# UNITED STATES PATENT AND TRADEMARK OFFICE

10/579,067

<b>Office Action Summary</b>	<b>Application No.</b> 10/579,067	<b>Applicant(s)</b> KOBUCHI ET AL.	
	<b>Examiner</b> CLAIRE L. ROE	<b>Art Unit</b> 1727

## **DETAILED ACTION**

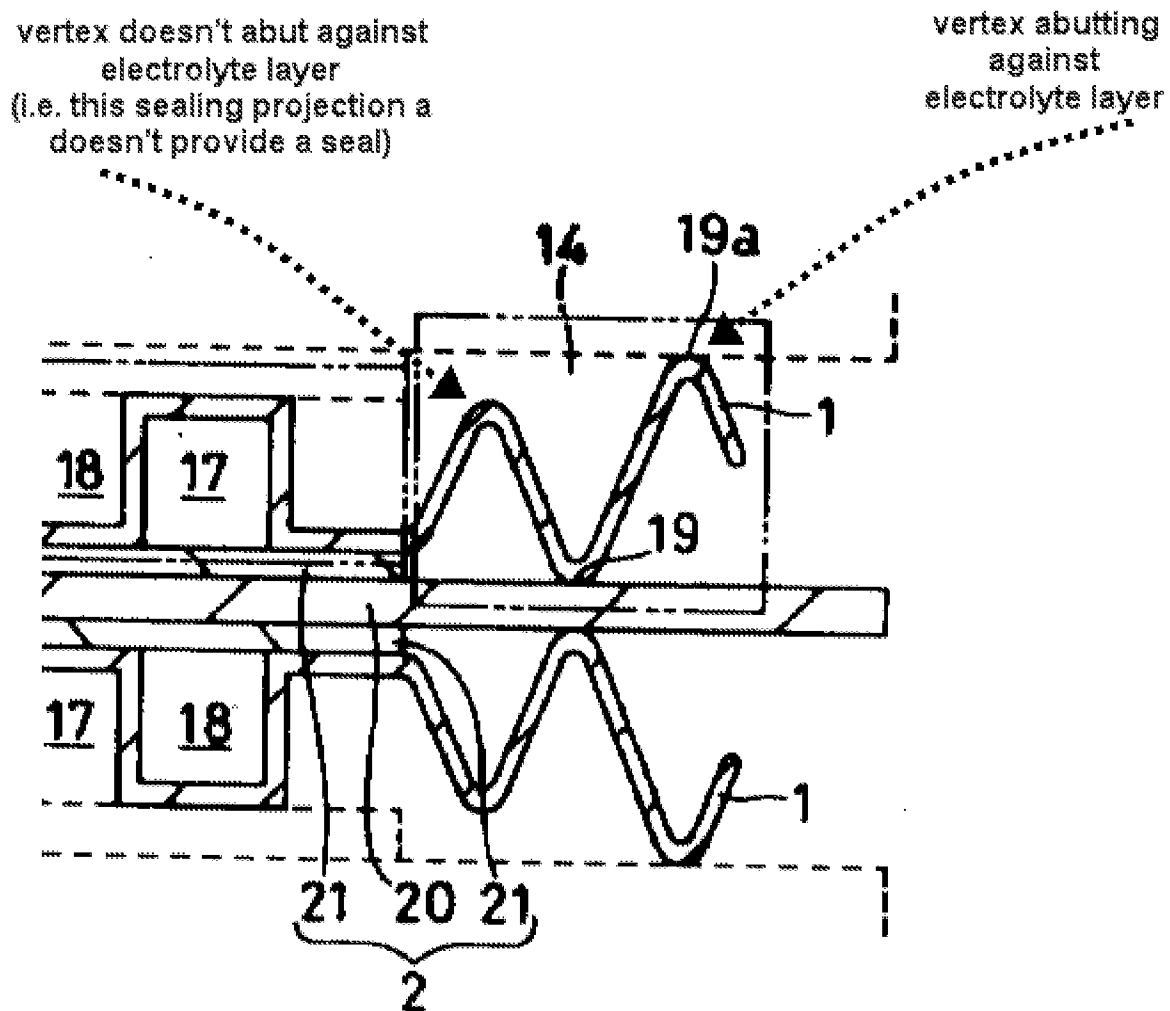
2. The drawings are objected to under 37 CFR 1.83(a). The drawings must show every feature of the invention specified in the claims. Therefore, the vertices (see claim 9 & 19a of Figure 2) of the sealing projections abutting against the electrolyte layer must be shown or the feature(s) canceled from the claim(s). No new matter should be entered. The following illustration (modified instant Figure 2) is provide for clarification:

Corrected drawing sheets in compliance with 37 CFR 1.121(d) are required in reply to the Office action to avoid abandonment of the application. Any amended replacement drawing sheet should include all of the figures appearing on the immediate prior version of the sheet, even if only one figure is being amended. The figure or figure number of an amended drawing should not be labeled as "amended." If a drawing figure is to be canceled, the appropriate figure must be removed from the replacement sheet, and where necessary, the remaining figures must be renumbered and appropriate
